ADDENDUM NO. 1

MIDWESTERN STATE UNIVERSITY
MOFFETT LIBRARY RENOVATION
PHASE I

Addendum Date: 2 April 2018

M-201

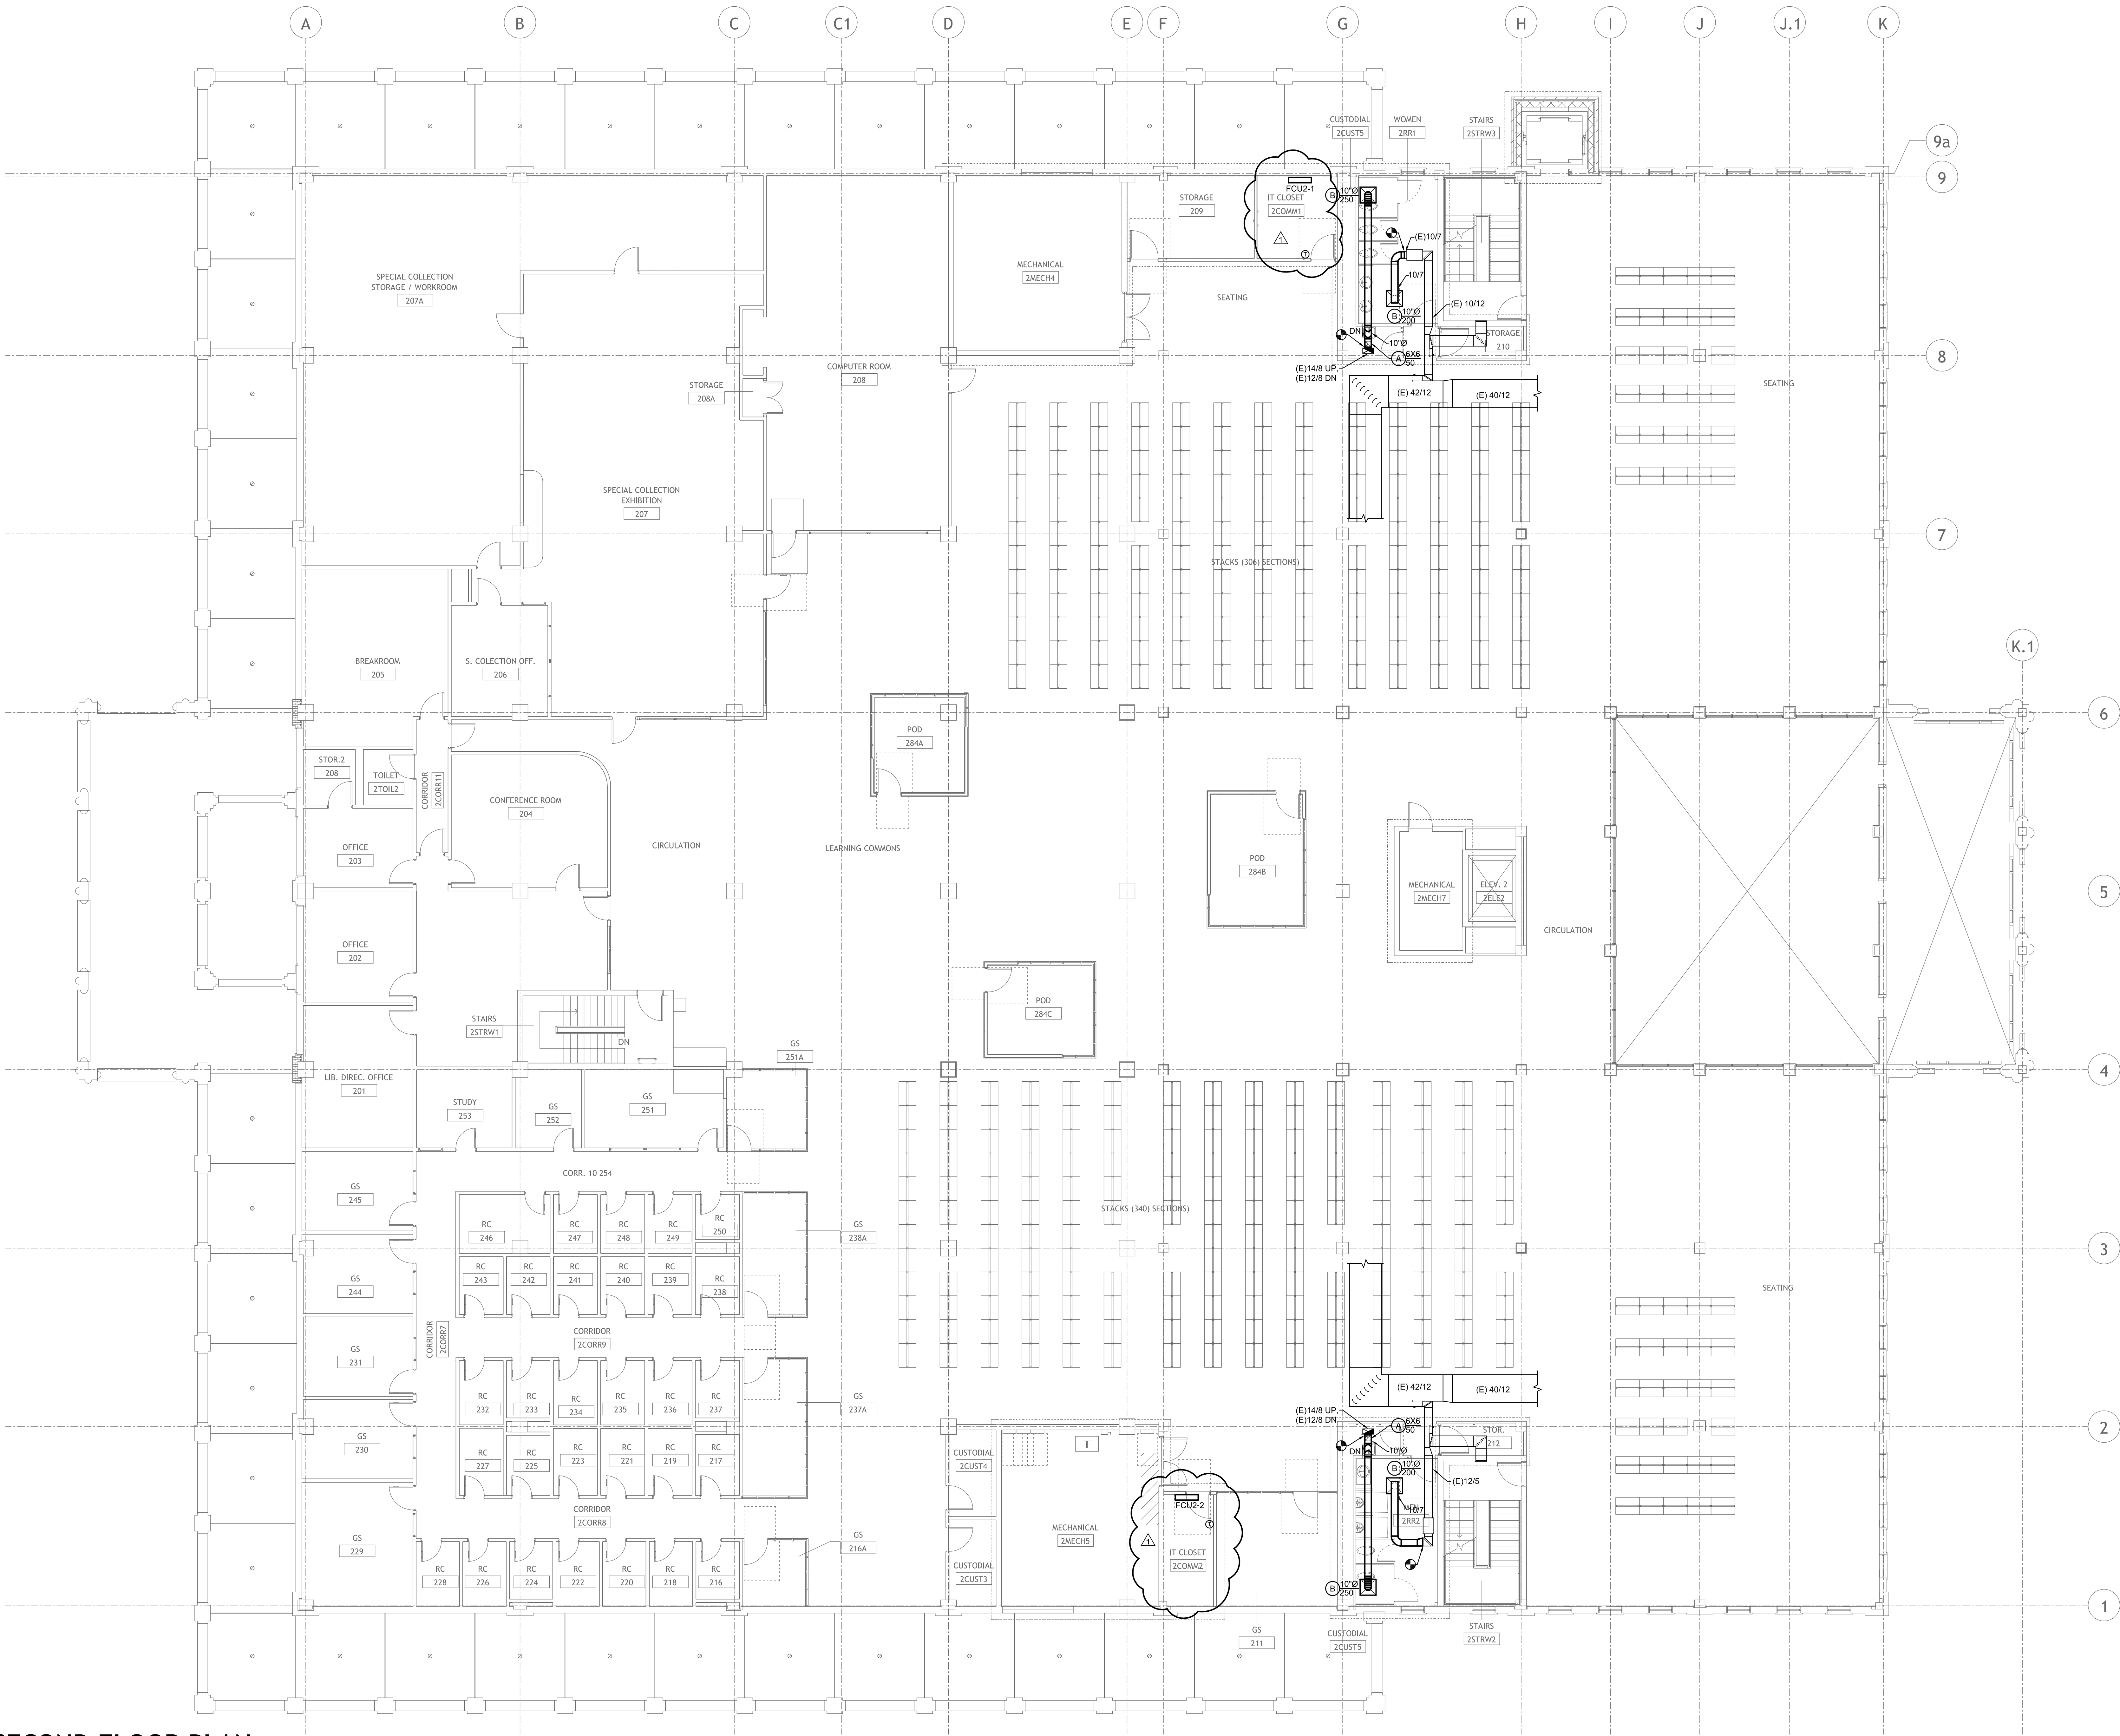
Replace the Drawings the revised Sheets attached in this Addendum. Additions and revisions have been made to the Mechanical Plans on all Floors, mainly relating to IT Closets.

E-103

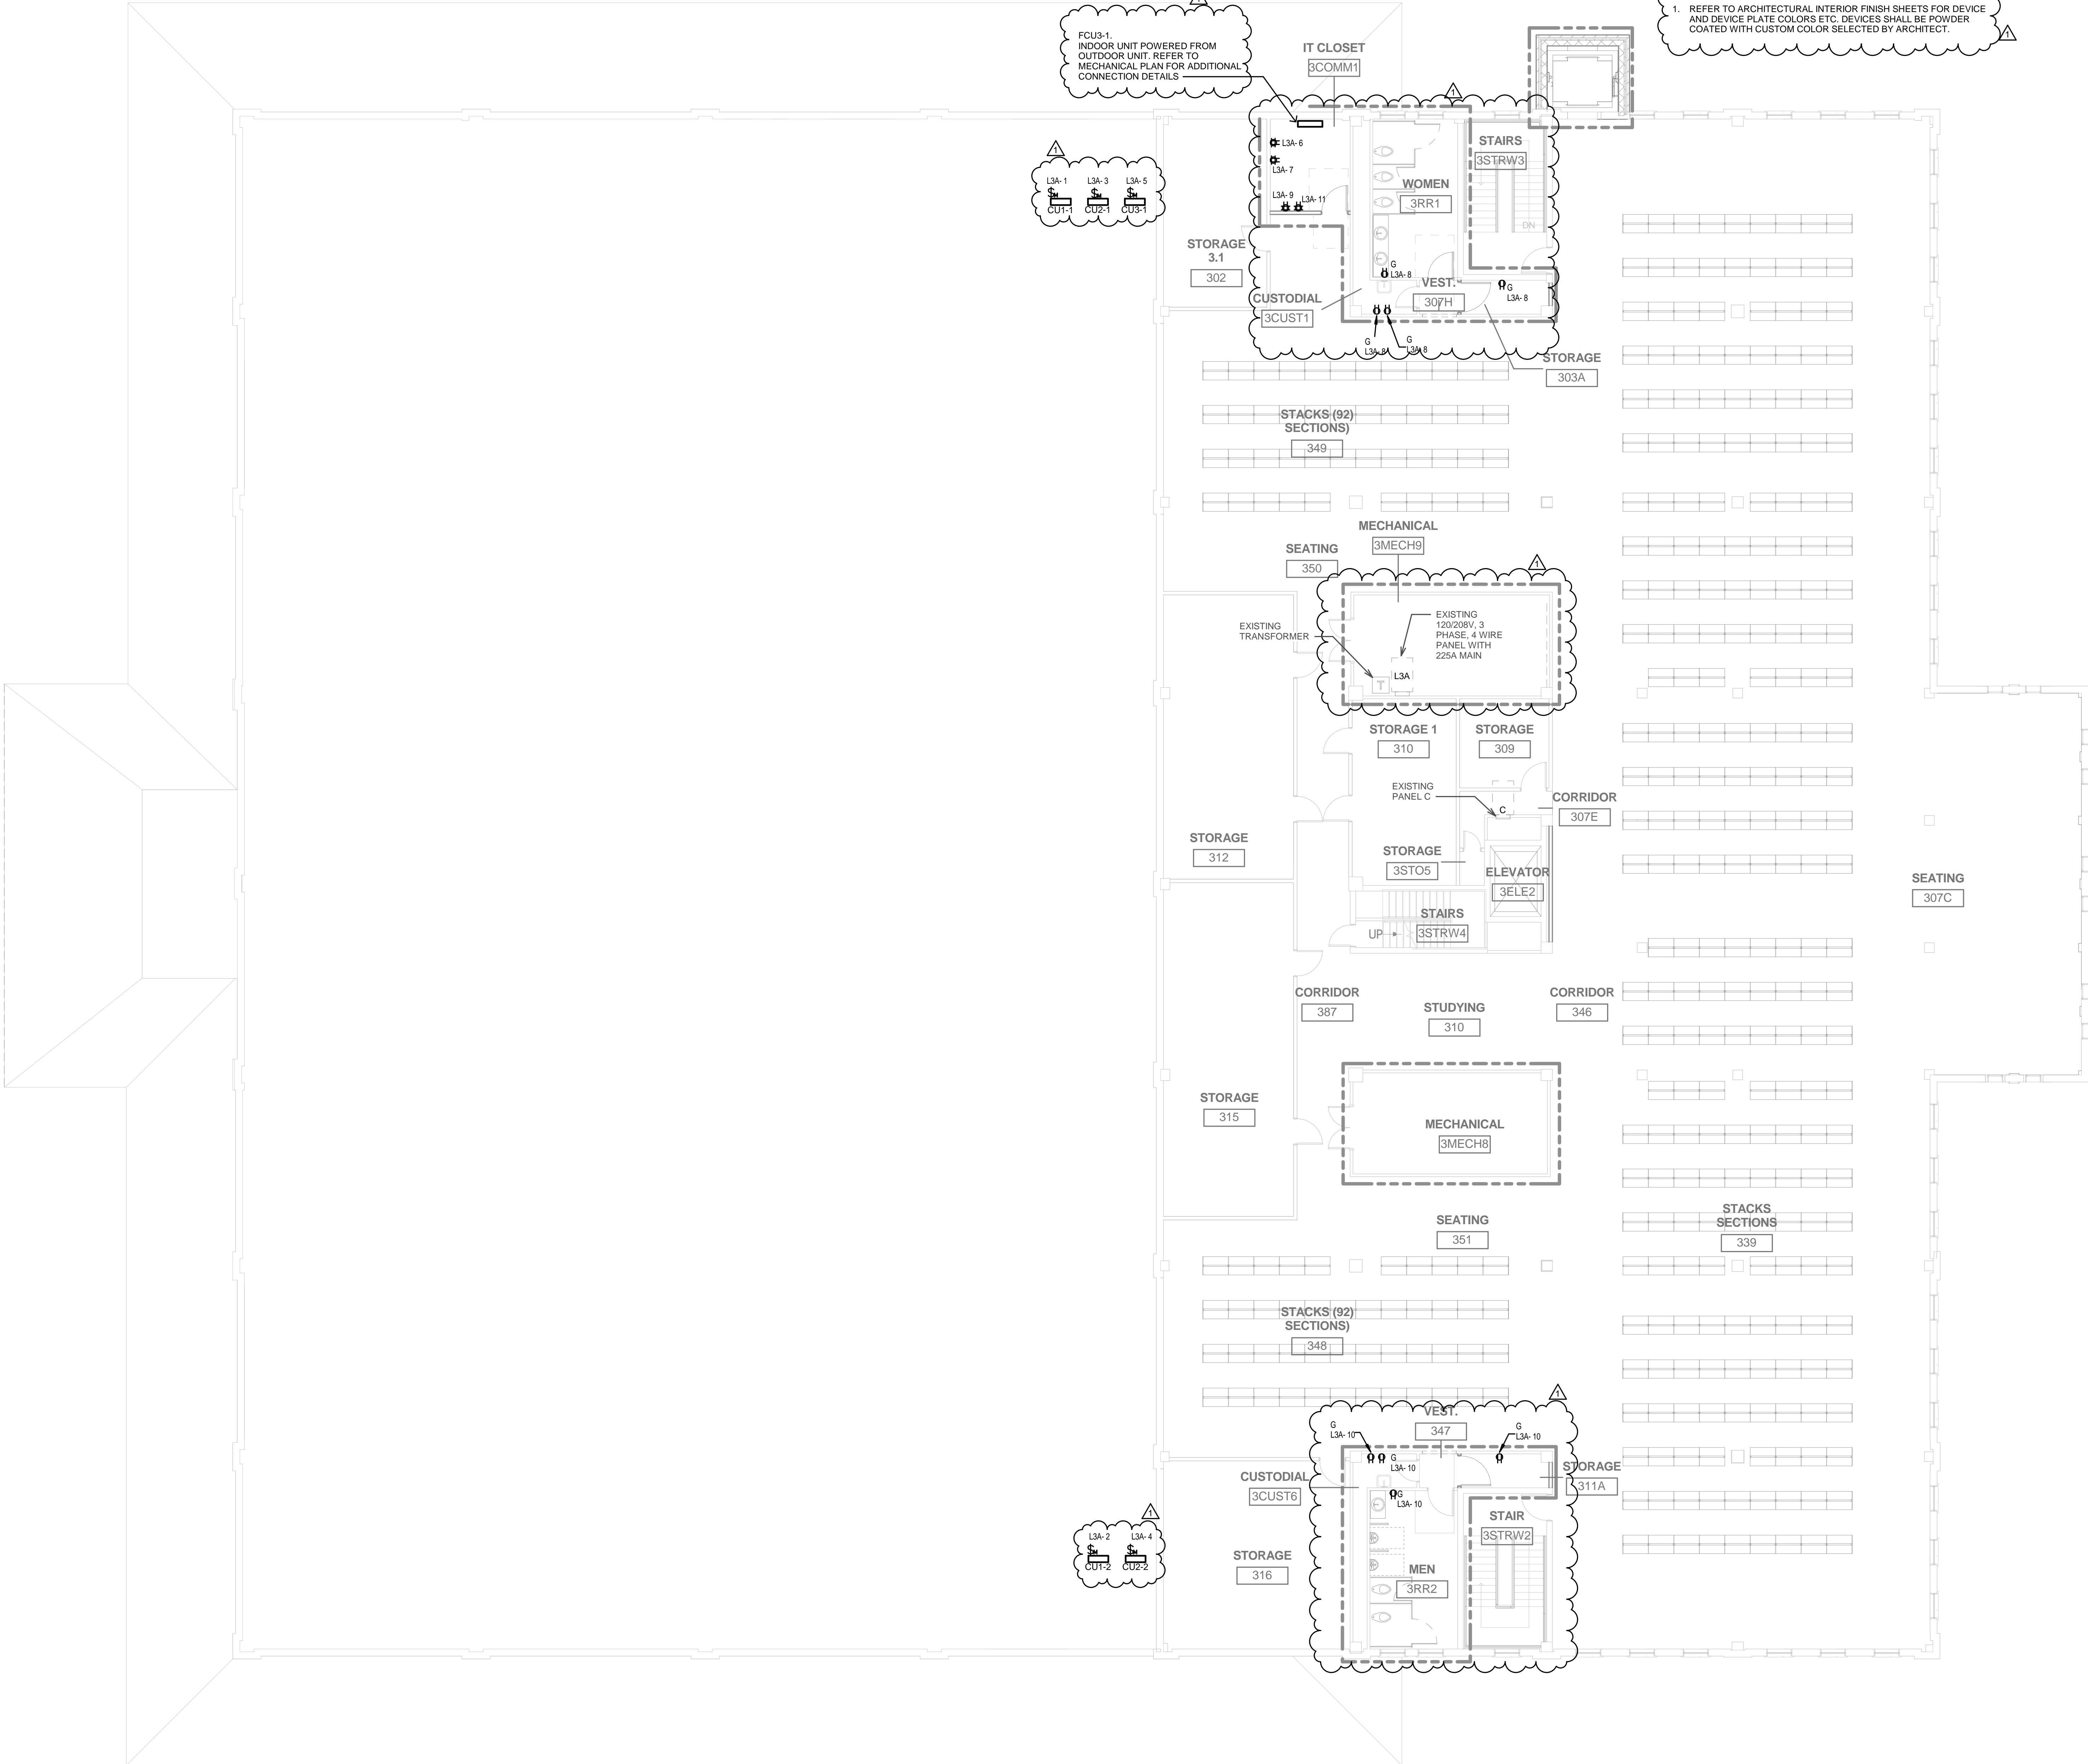
Replace the Drawings the revised Sheets attached in this Addendum. Additions and revisions have been made to the Electrical Plans on all Floors and Electrical Demolition Plan on the 1st Floor, mainly relating to IT Closets. Also, revisions have been made to the "POWER SYMBOL LEGEND" and the "ELECTRICAL DEMO FIRST FLOOR".

P-101

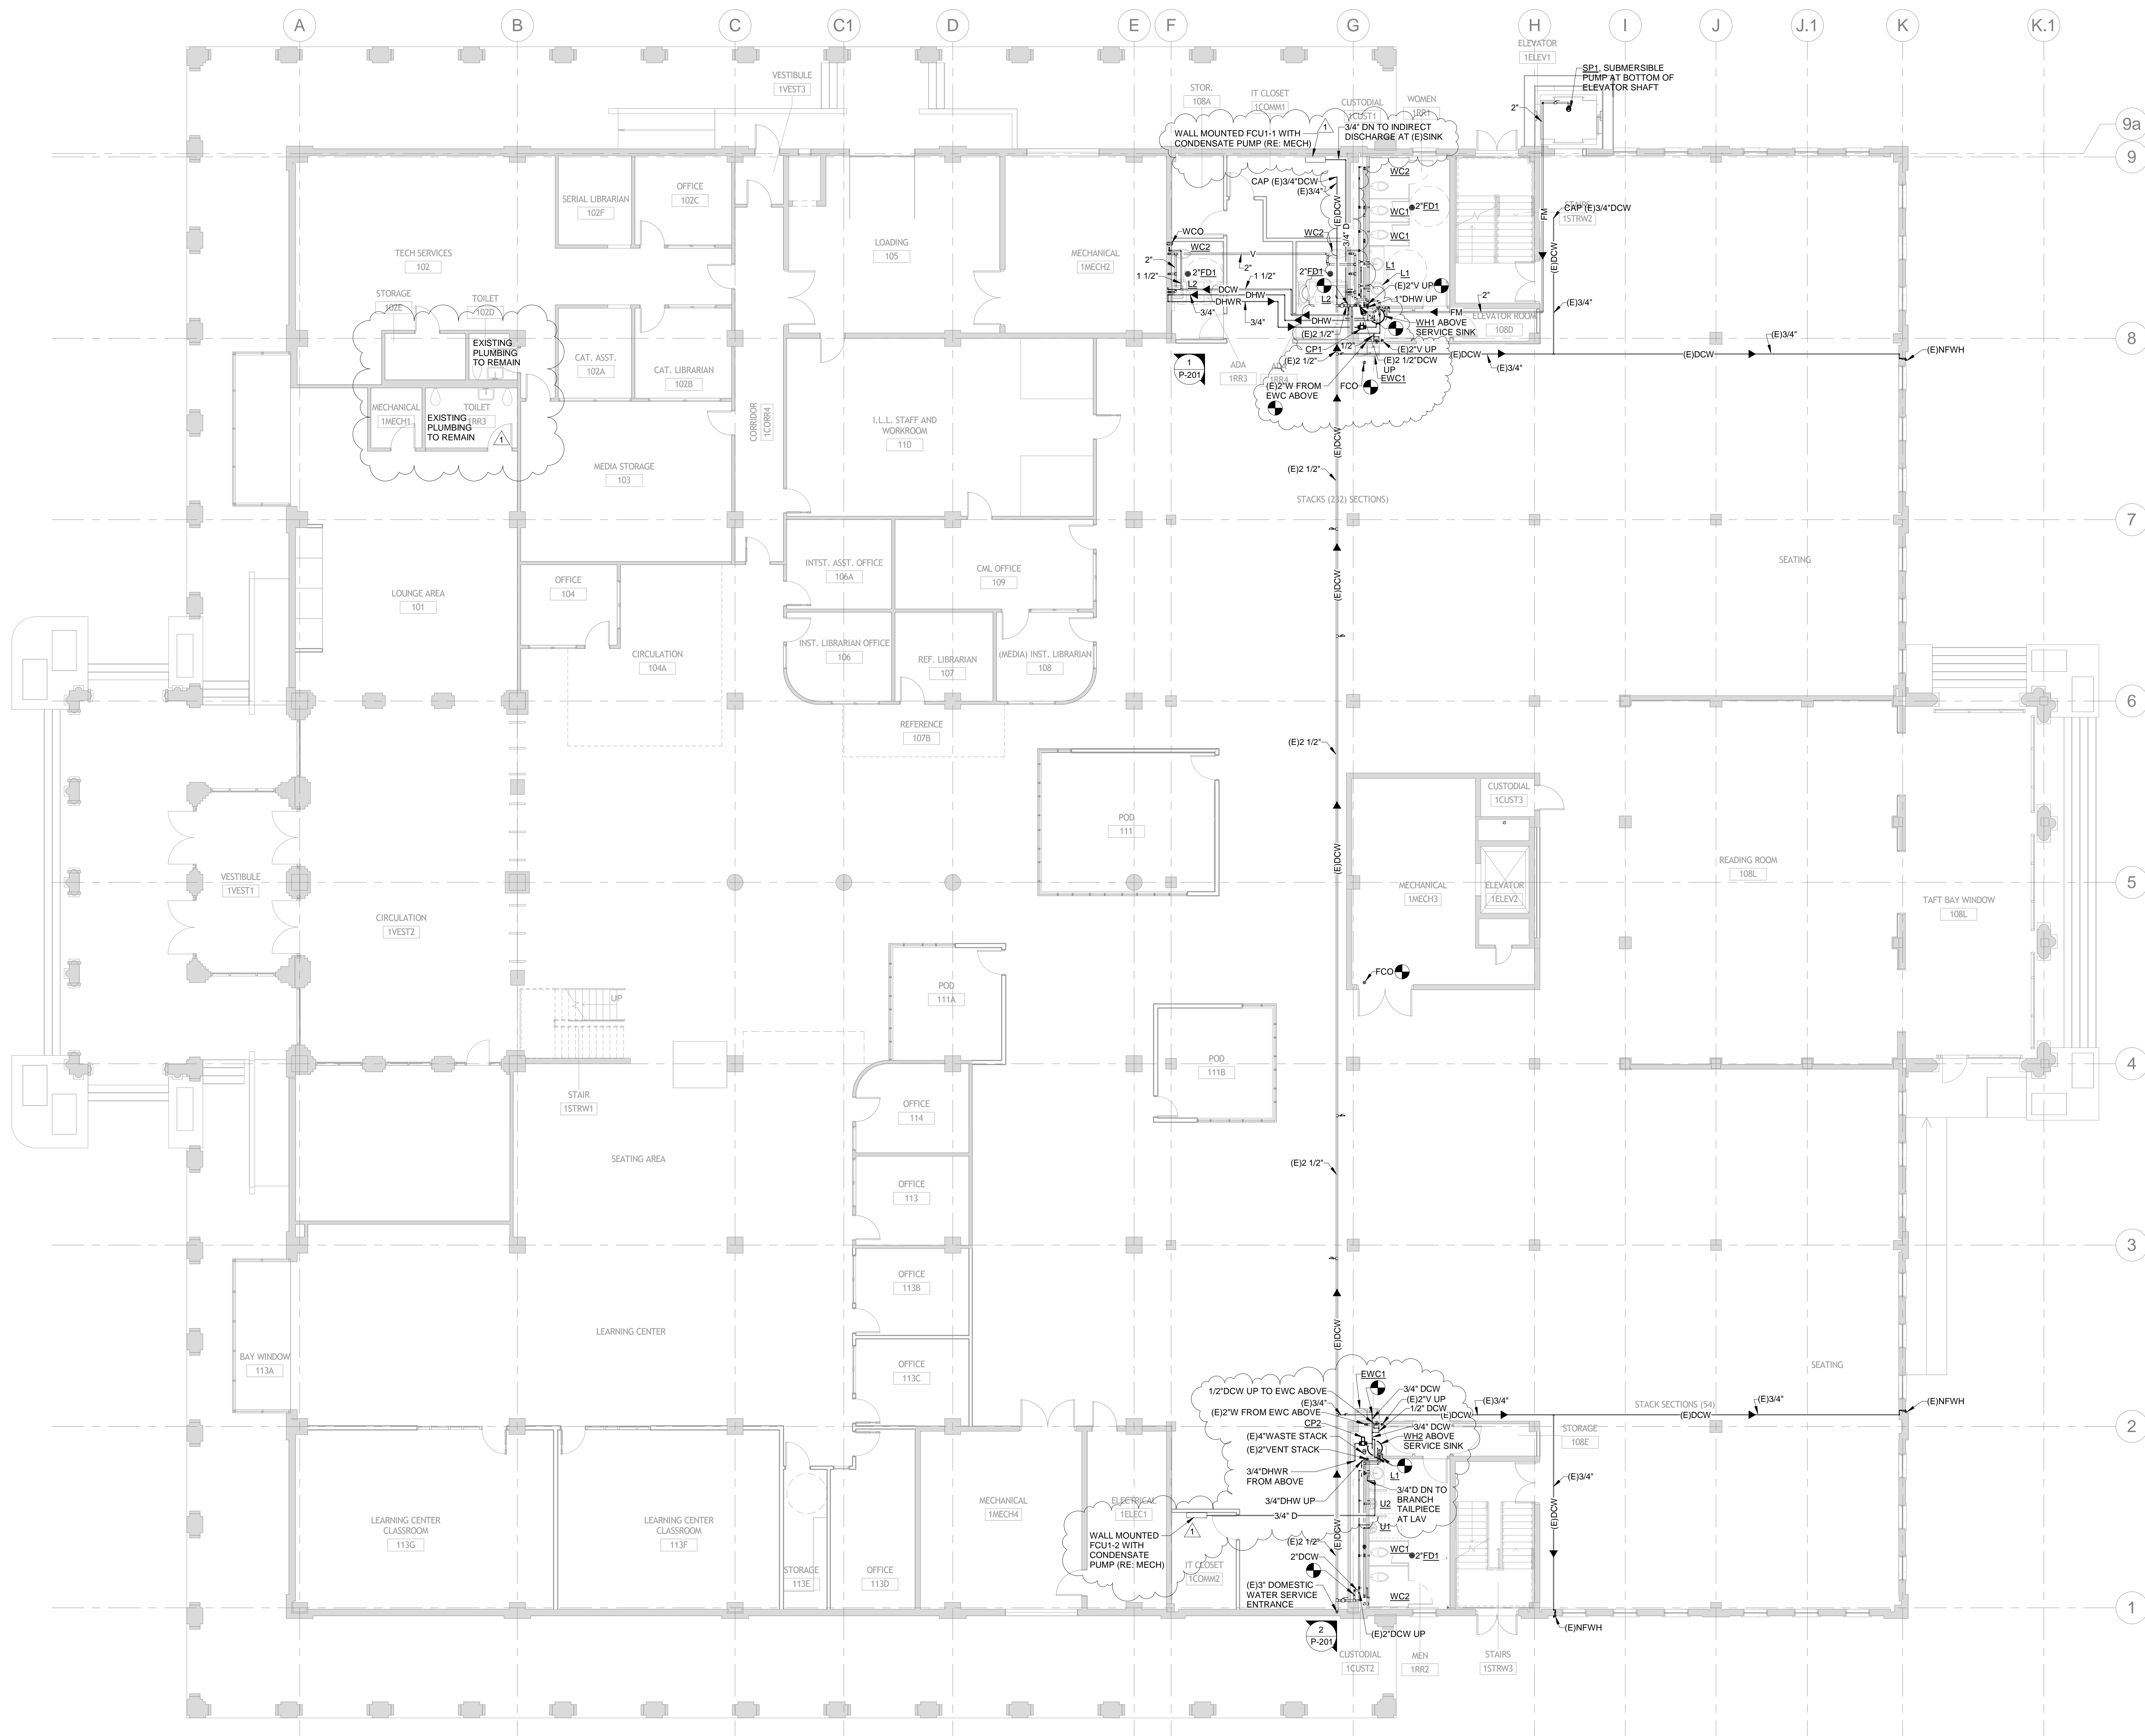
Replace the Drawings the revised Sheets attached in this Addendum. Additions and revisions have been made to the Plumbing Plans and Plumbing Demolition Plans on all Floors, mainly relating to Electric Water Cooler Units and IT Closets. Also, revisions have been made to the "PLUMBING FIXTURE SCHEDULE" and the "ELECTRICAL DEMO FIRST FLOOR".
